## PLANNING AND ZONING CASE CHECKLIST

P2022-010 te Plan for Fuji Ceramics 586 S GOLIAD ST CASE MANAGER: CASE MANAGER PHONE: CASE MANAGER EMAIL: Henry Lee 972.772.6434 hlee@rockwall.com

CASE CAPTION: Discuss and consider a request by Jeff Carroll of Jeff Carroll Architects, Inc. on behalf of Kip Estep for the approval of a Site Plan for an Office Building in conjunction with an existing medical manufacturing company on a 1.617-acre parcel of land identified as Lot 1, Block A, Estep Subdivision, City of Rockwall, Rockwall County, Texas, zoned Commercial (C) District, situated within the SH-205 Overlay (SH-205 OV) District, addressed as 2686 S. Goliad Street [SH-205], and take any action necessary.

TO:	Planning and Zoning Commission
DATE:	April 12, 2022
APPLICANT:	Jeff Carroll; Jeff Carroll Architects, Inc.
CASE NUMBER:	SP2022-010; Site Plan for Fuji Ceramics

## EXTERIOR ELEVATIONS

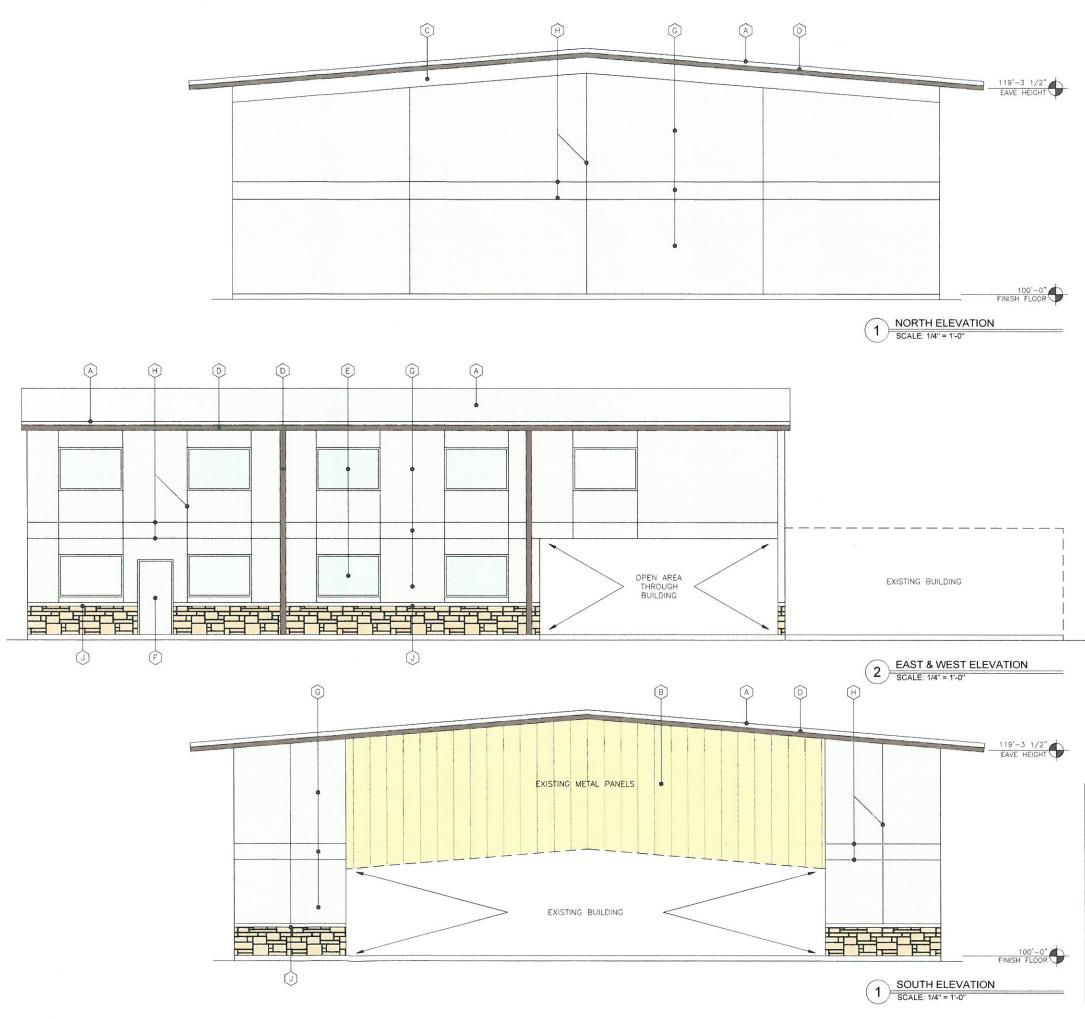
#### M.10 Building Elevations:

(1) Provide the material percentages for all materials on the building. (Subsection 05.01, of Article 05)

(2) Depending on the material percentages you may not meet the 20% natural stone requirement and you may exceed the 50% Stucco allowance. These would be variances to the code if not corrected. (Subsection 05.01, of Article 05)

(3) The horizontal articulation standard is not met; the wall lengths are greater than three (3) times the height of the proposed building. This will serve as a requested variance to the Unified Development Code (UDC). (Subsection 05.01. C, of Article 05)

- 1) The rear building corners off the property line have been adjusted to reflect the correct dimensions.
- 2) The owner has agreed to add the wainscot on the south elevation. We also noticed the stone on the existing buildings are a thin stone. Not natural. We need to match what is existing.
- 3) The drive around the site has a ONE-WAY direction around the buildings. The fire lanes around the site have been adjusted per what is striped. On the north property line, they are parked over the fire lane stripe leaving 18'-0" clear for the one-way direction. The remaining drive has a 24'-0" wide fire lane which goes down to 22'-0" at both entry and exit points.

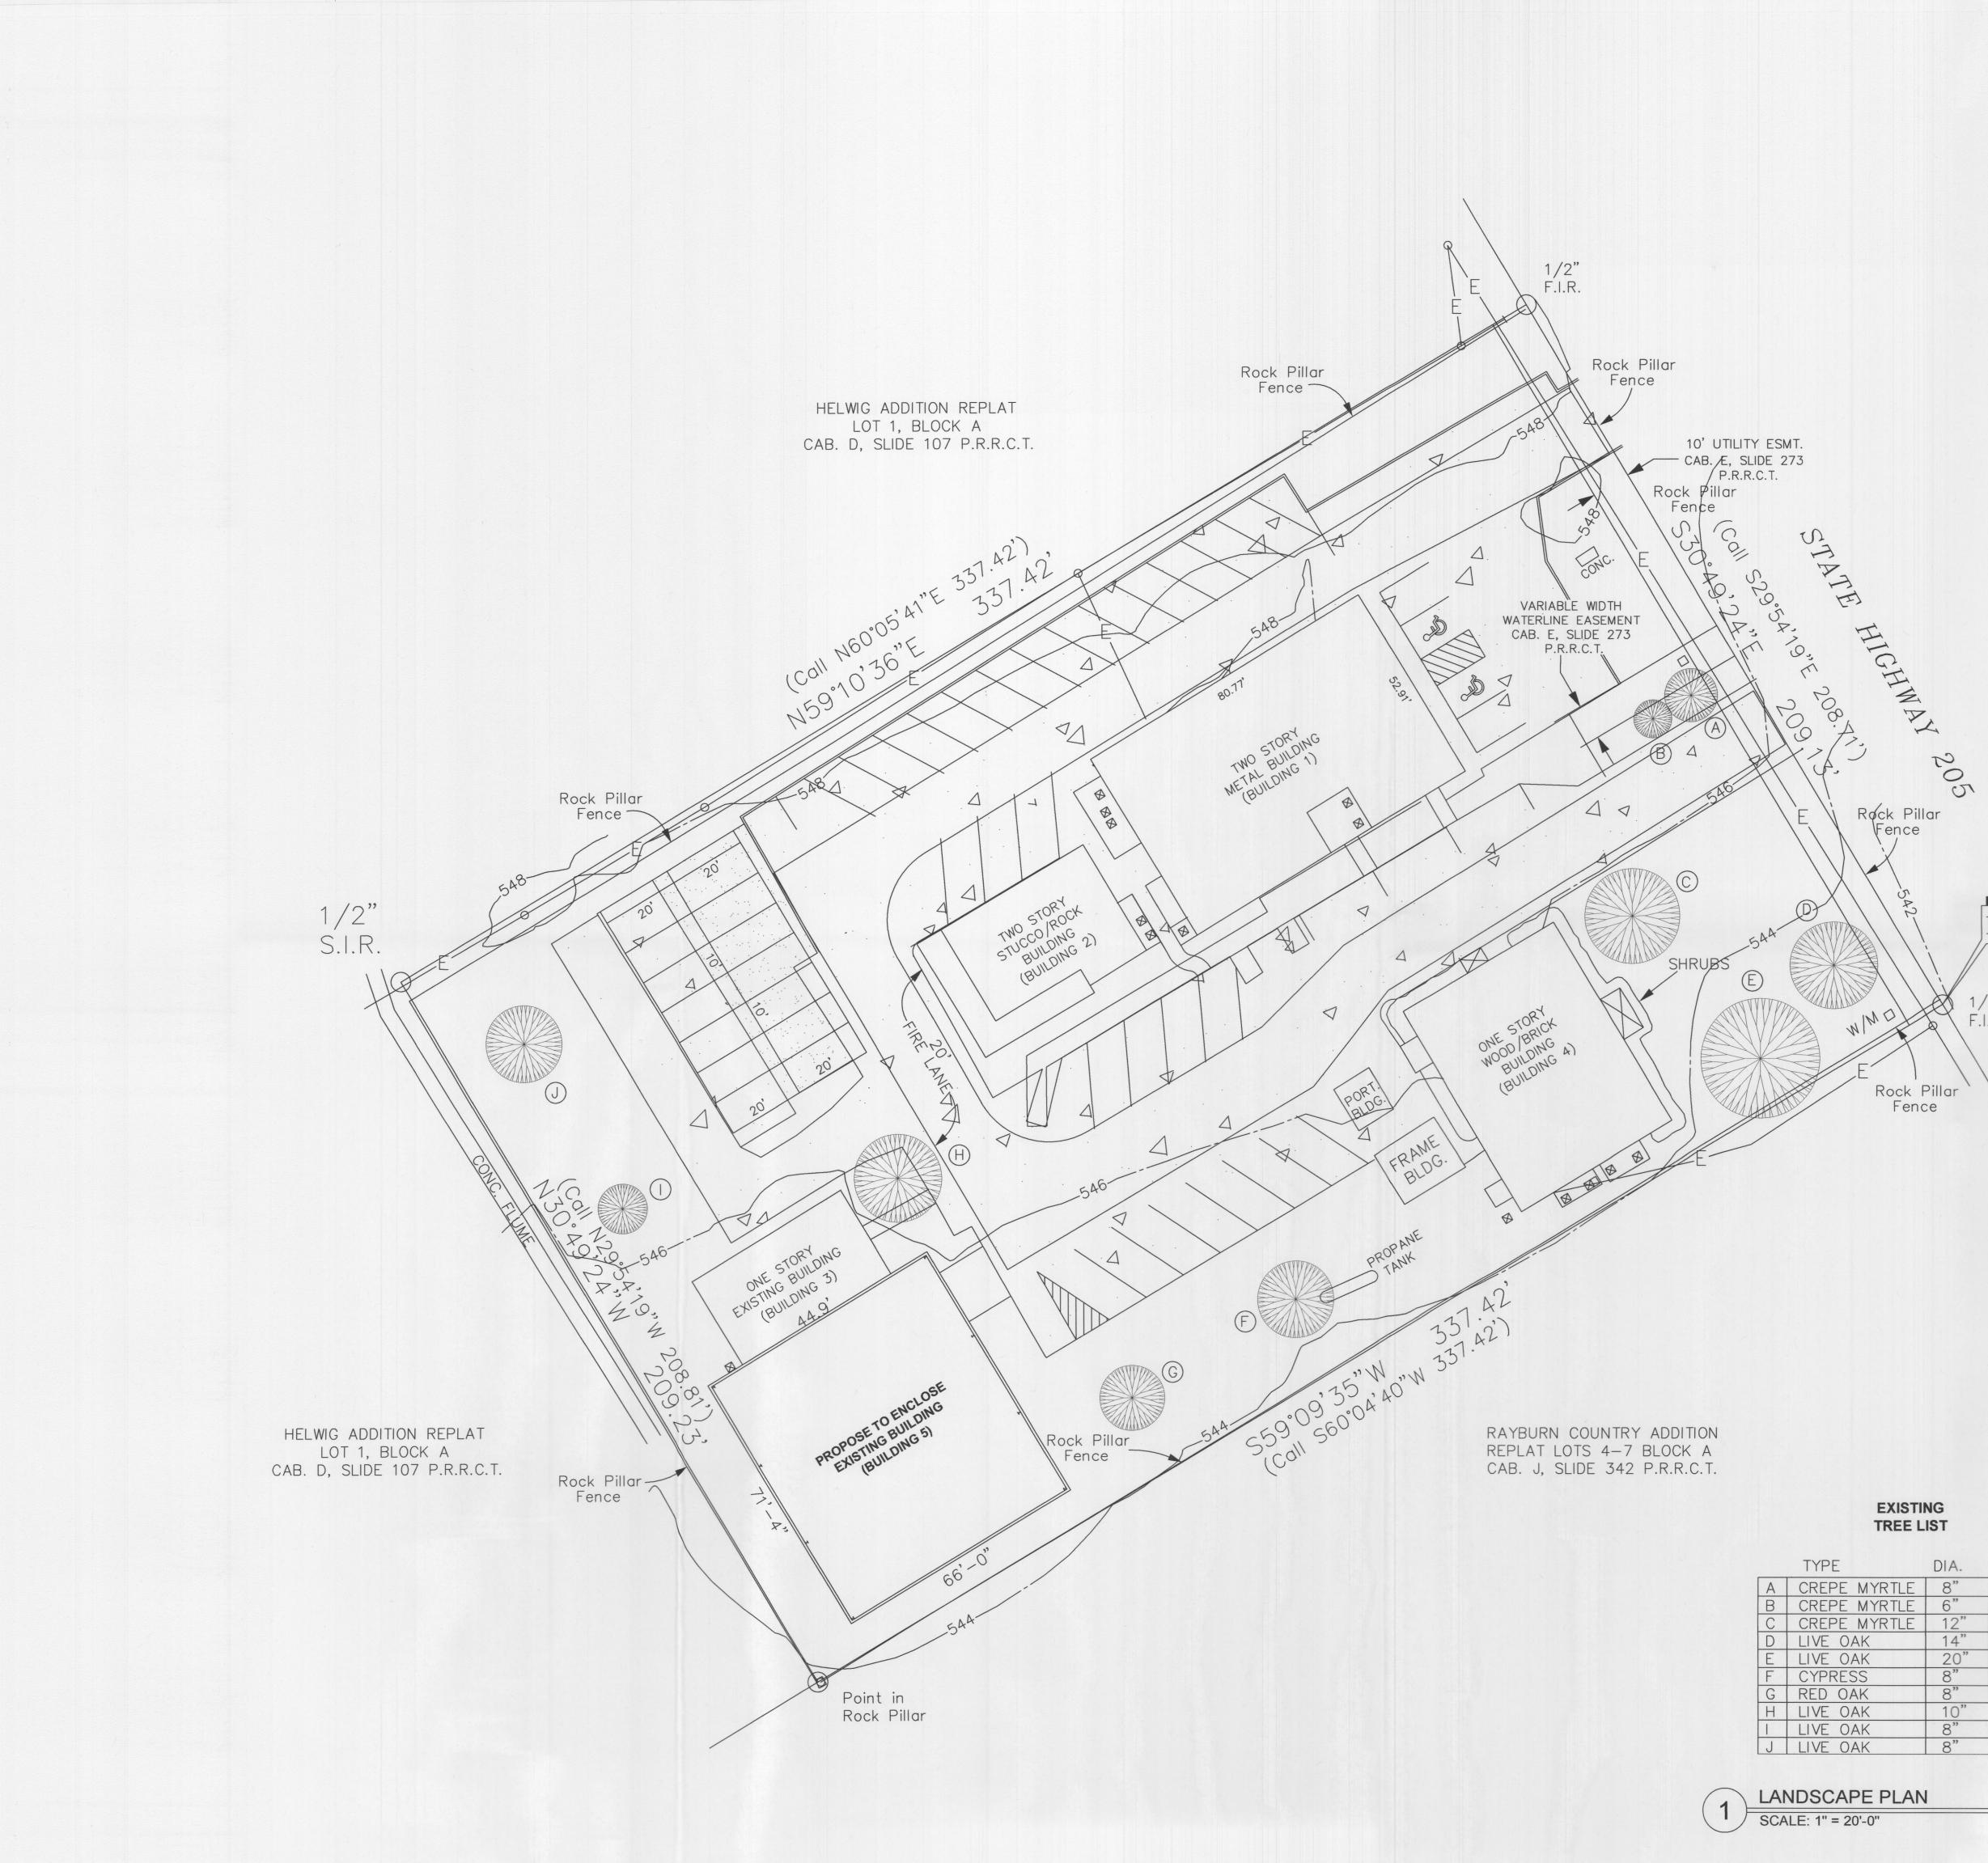
M.7 Site Plan:

- (1) Indicate the Lot area in acres and square feet. (Subsection 03.04. B, of Article 11)
- (2) Indicate the proposed building square footage. (Subsection 03.04. B, of Article 11)

- (3) Indicate the distance between buildings. (Subsection 03.04. B, of Article 11)
- (4) Indicate the distance between the proposed building and the property lines. (Subsection 03.04. B, of Article 11)

- (5) Indicate the building setbacks. (Subsection 03.04. B, of Article 11)
- (6) Please indicate all easements. Are there any utility easements on the property? (Subsection 03.04. B, of Article 11)

- (7) Indicate the location of all existing and any proposed fire hydrants. (Subsection 03.04. B, of Article 11)
- (8) Please label the Right-of-Way for S. Goliad Street. (Subsection 03.04. B, of Article 11)

- (9) Please label the centerline for S. Goliad Street. (Subsection 03.04. B, of Article 11)
- (10) Is there any pad mounted or roof mounted utility equipment? If so indicate the subsequent screening. (Subsection 01.05. C, of Article 05)

- (11) Is there a dumpster on site? If so, please indicate it as well as the screening. (01.05. B, of Article 05)

03/23/2022: - Show the 24x15' parking turnaround location at the northwest corner.

Attached is the revised site plan based on us walking/ measuring the site today. Also is the revised elevations adding stone on the north side.
